16/01563/F Muddle Barn Farm, Colony Road, Sibford Gower

Demolition of an existing dwelling and a range of large scale equestrian buildings and the erection of a replacement dwelling including associated works and landscaping (resubmission 15/01693/F)

Image 26
Typical details of sliding sash window with caset frame

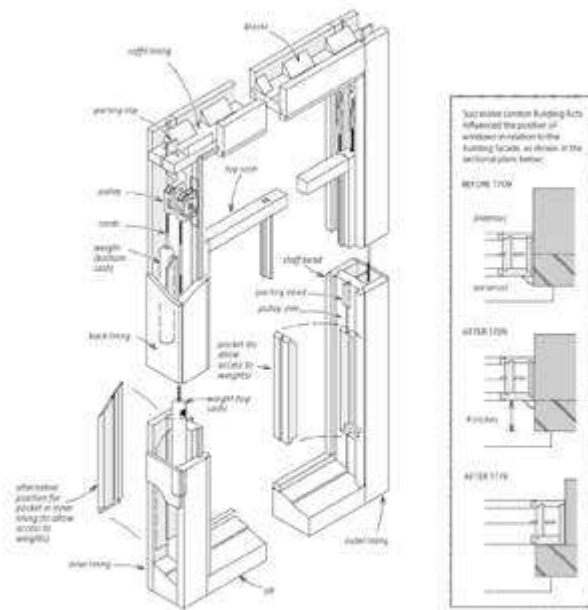
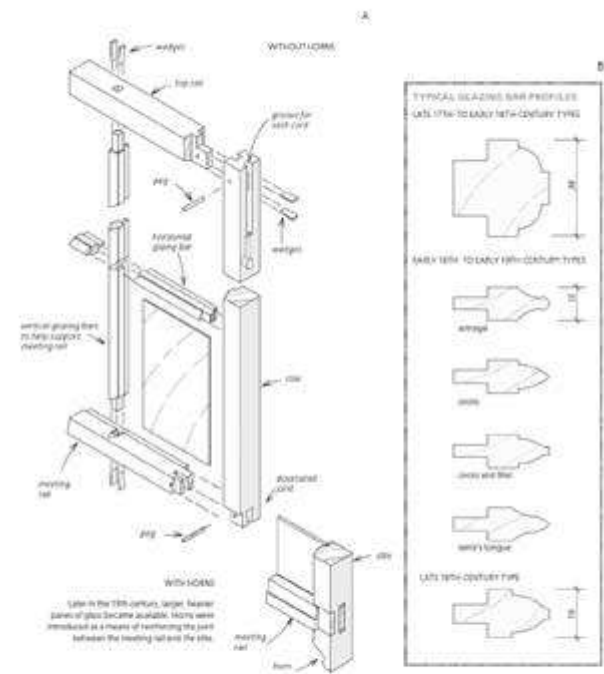
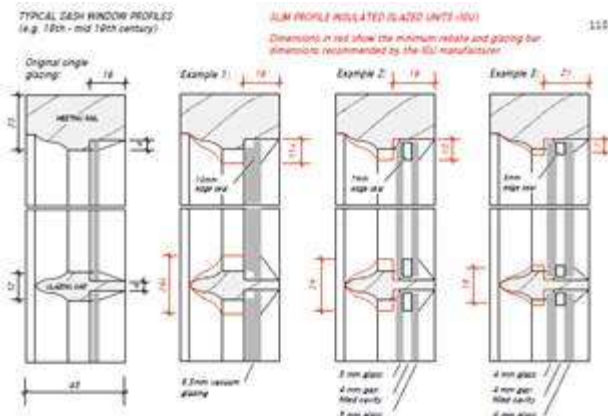
- Timber sliding sash and case windows and colour:
Detail submitted shows sash box hidden in stone reveal (typical detail after 1774 in London by law, later copied in other parts of the country) with glazing bars at 35mm wide (typical 38mm in late 17thC/ early 18thC but by late 18thC the glazing bars had slimmed down), Historic England '<https://content.historicengland.org.uk/images-books/publications/traditional-windows-care-repair-upgrading/heag039-traditional-windows.pdf/>' + need to think about avoiding cold bridging and draftstripping in due course. Historic England illustrate slimline double glazing with an 18mm glazing bar. The colour of the spacer bar/edge between the two sheets of glass needs to have a non-metallic finish – matt black might work better with certain colours, especially if an off white or colour is proposed suggest trialing which colour looks best with chosen window colour.
